SERVICE LETTER 217

Cessna 208 & 208B Exhaust Duct & Engine Cowling Repair

Aircraft Makes/Model(s):	Float Model(s):	Compliance: Mandatory	By: MAB
Textron Aviation 208 & 208B	8750	Part Number: 1011606	Approved: SDW
		Date: 2/3/2021	Revision: B

Figure 1 Lower Right Cowl - Exterior

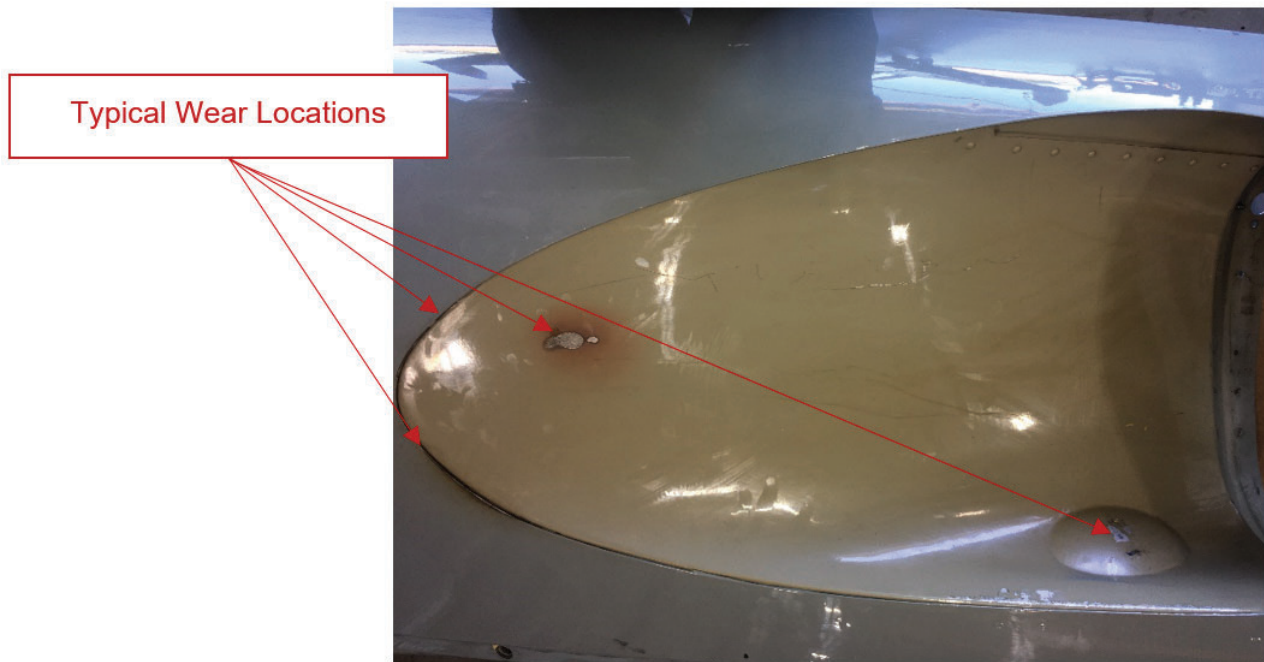
1. Using a flashlight visually inspect cowling and exhaust for wear; areas of reduced clearance are shown in Figure 1.

Figure 2 - Lower Right Cowl - Interior

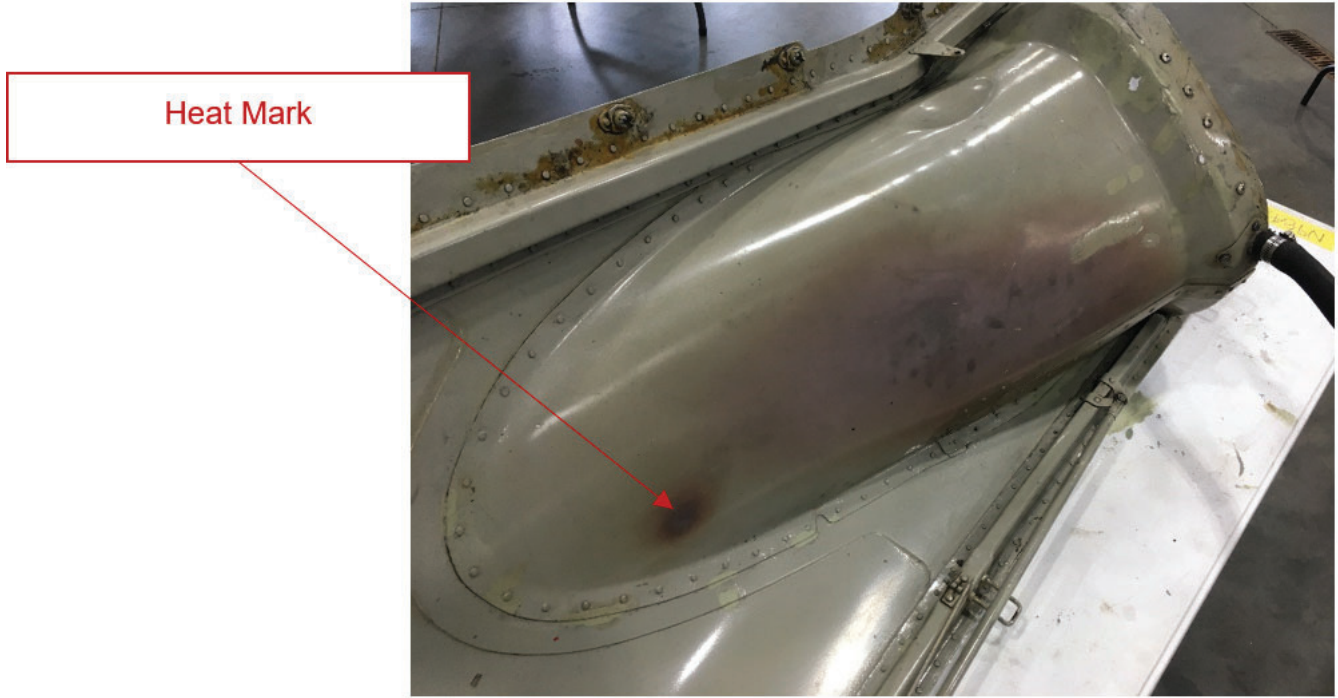
2. Inspect exhaust and cowling to determine existing clearance. The desired exhaust to cowling clearance is .25 inches. The desired fly-wire to exhaust clearance is 0.31 inches.
3. Open right hand cowl door; inspect inner cowl panel for heat marks as shown in Figure 2.

Figure 4 - Heatshield Area

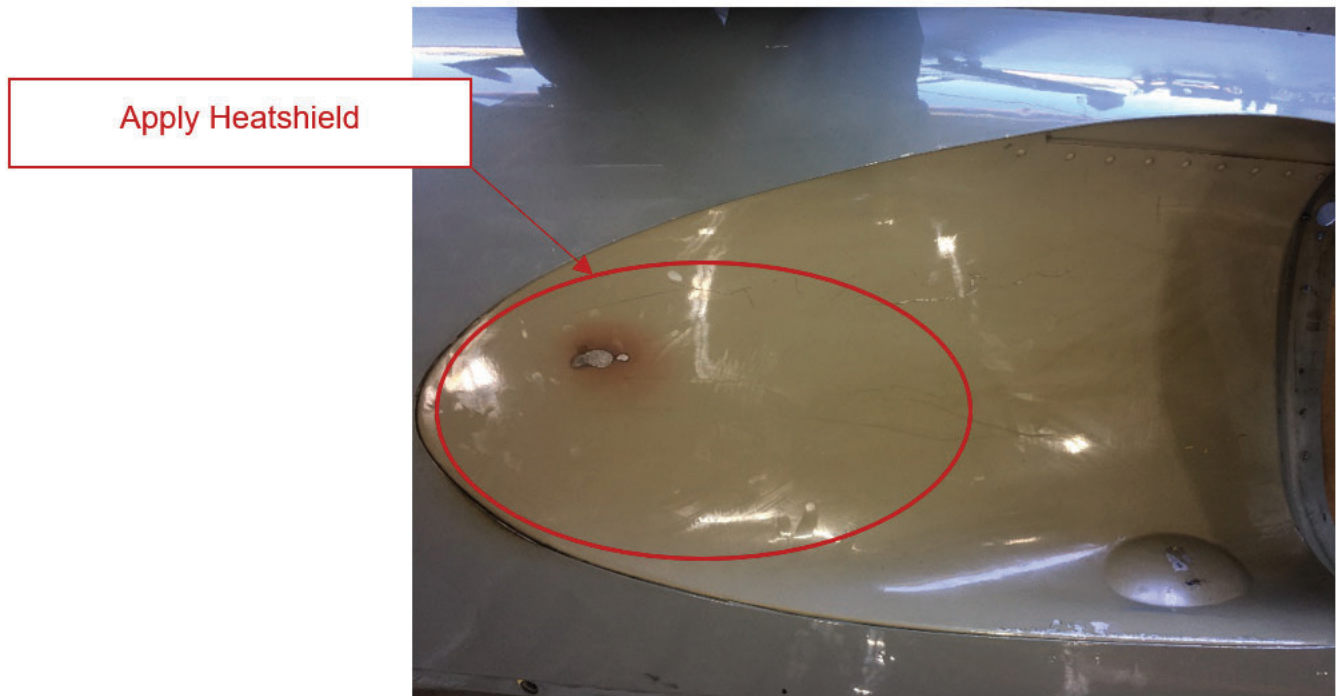
1. Remove lower right cowl per Cessna AMM.
2. Remove oil breather attach neck from cowl (3 bolts).
3. Remove secondary exhaust from cowl (8 screws).
4. Observe any areas of wear. Trim the cowling skin to match the inner panel from the rear of the cowling to a point 36.0 inches forward as needed for clearance (blend smoothly with forward opening); the skin may also be chamfered.
5. Clean exterior surface of inner cowl panel.
6. Apply epoxy primer to areas of bare aluminum.
7. Apply 1011605 self-adhesive heatshield to exterior of cowling (aft portion of inner cowl panel).

Figure 5 - Exhaust Hanger Brackets

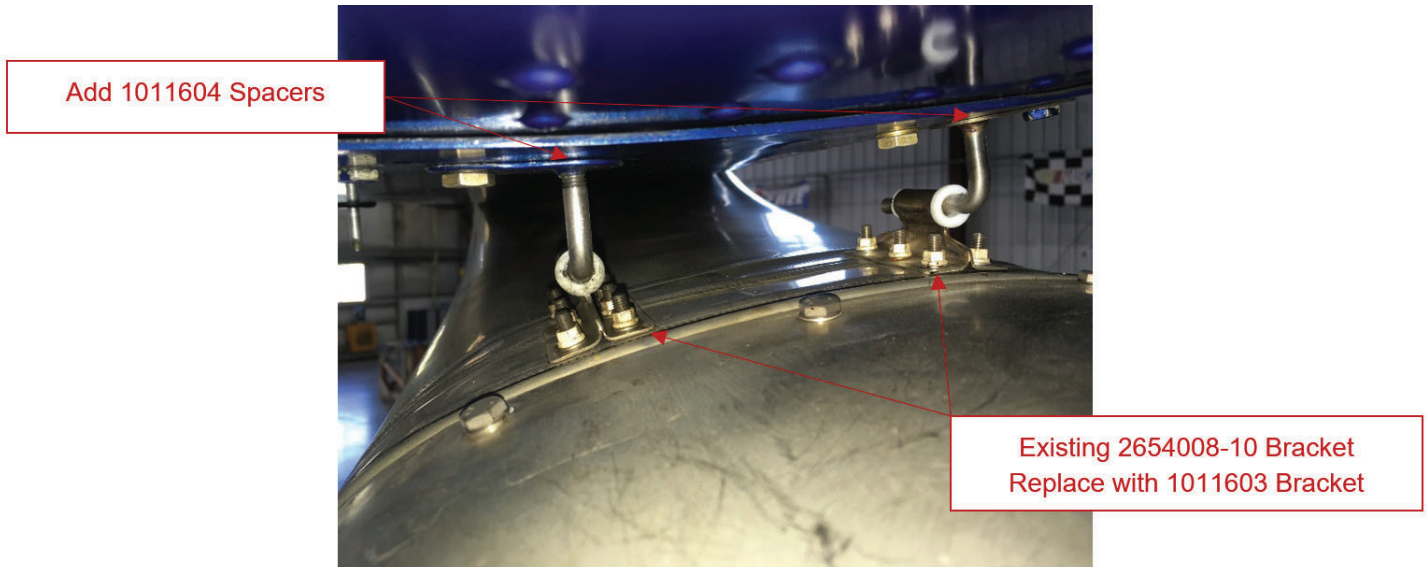
NOTE: 1011604 spacers may also be installed (up to three at each hanger). The spacers will reduce fly-wire clearance (0.31 inches should be maintained). To install spacers: remove hanger, place spacer between hanger and cowl, install with original hardware (a longer MS35207 screw may be required).

10. Remove 2654008-10 brackets from secondary exhaust (12 bolts).
 11. Remove 2654008-14 bushings from 2654008-10 bracket and install bushings in replacement 1011603 brackets.

12. Position 1011603 brackets on exhaust hangers.
- NOTE:** Position exhaust bracket with short leg aft.
13. Position 1011603 brackets (12 bolts) with secondary exhaust (bolts should be loose enough to allow bracket to move in relation to the exhaust; the bolts will be tightened in step 20).
